A/E Firm: WRA Architects		PM Firm: CBRE Vanir JV	Date: 12-10-2025
Org #: 159	School Name: L.L. Hotchkiss Elementary School	Bid Pack #/ CSP#: 207325	Addendum #: 1

**DALLAS INDEPENDENT SCHOOL DISTRICT
PROCUREMENT SERVICES
ADDENDUM NO. 1
CSP 207325 – L.L. Hotchkiss Elementary School - Renovation**

The Purpose of this Addendum No. 1 is to provide an alternate bid and updated the drawings and specifications:

REVISIONS:	
No.	Date
1	Addendum #01 12/10/2025
Floor Plan Level 2 Overall	
A202	
© WRA Architects, Inc. 2024

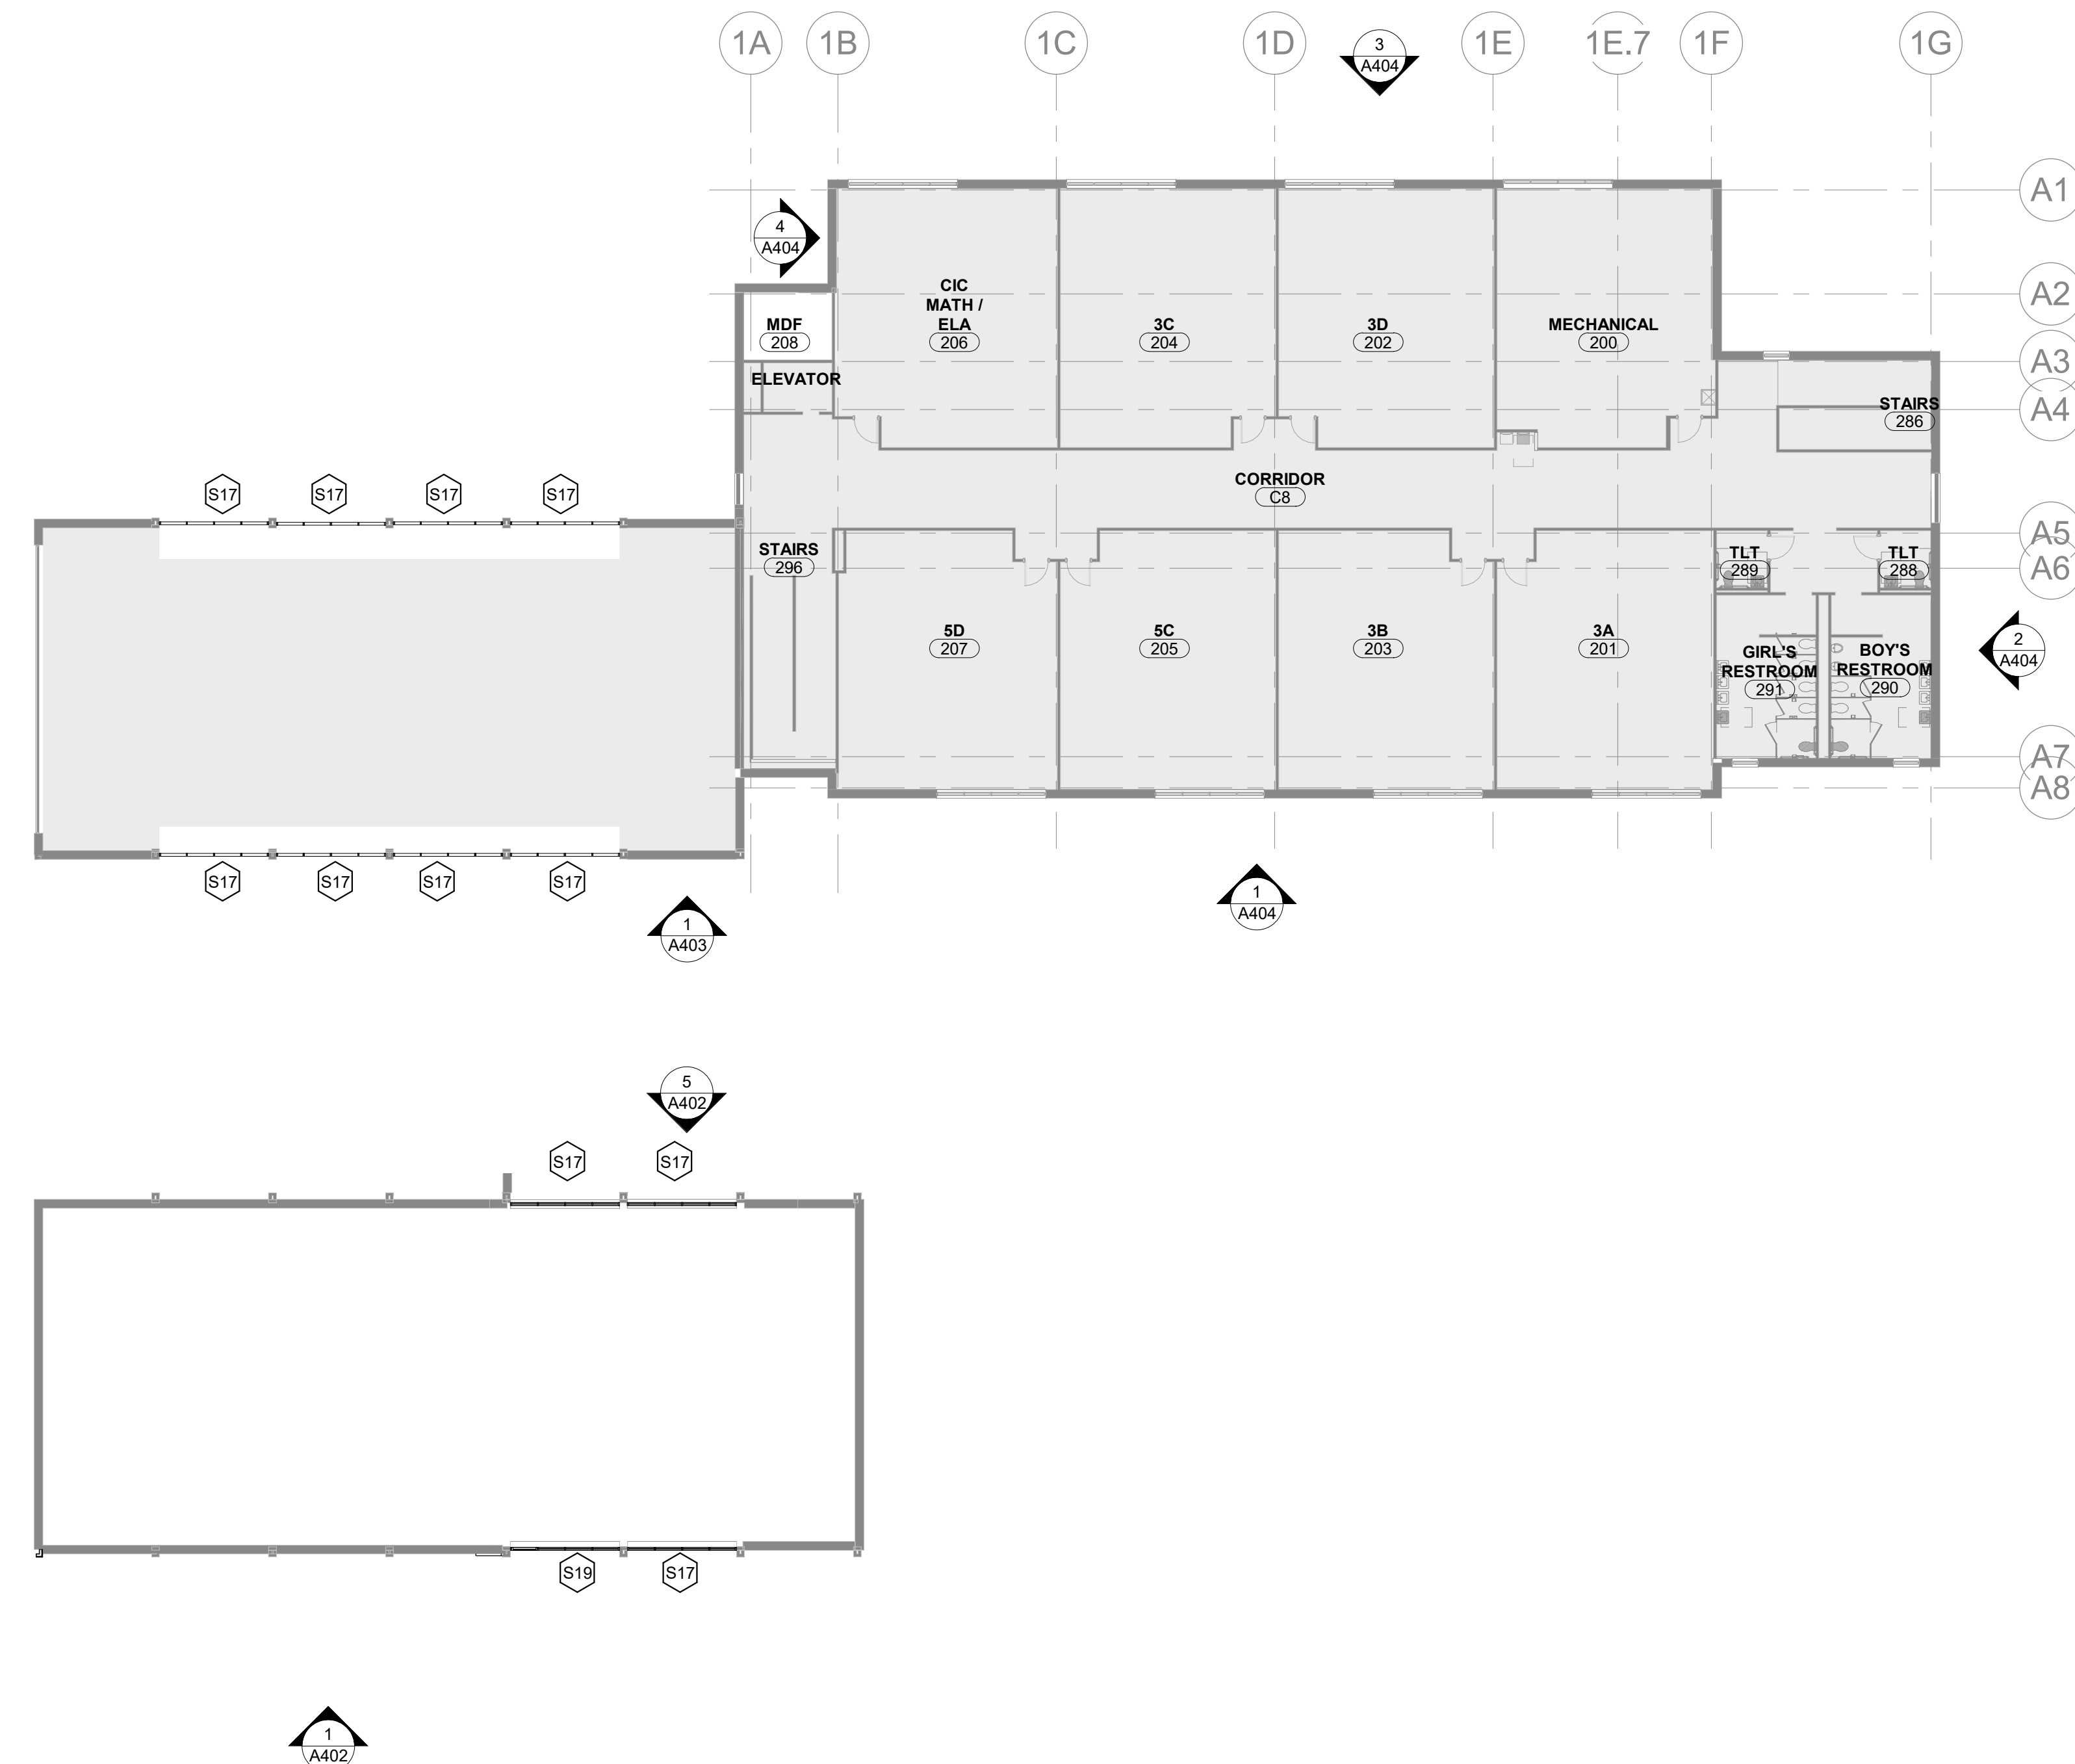
- A. Modified the window blind tags in the floor plan symbol legend to read as window roller shade tag.
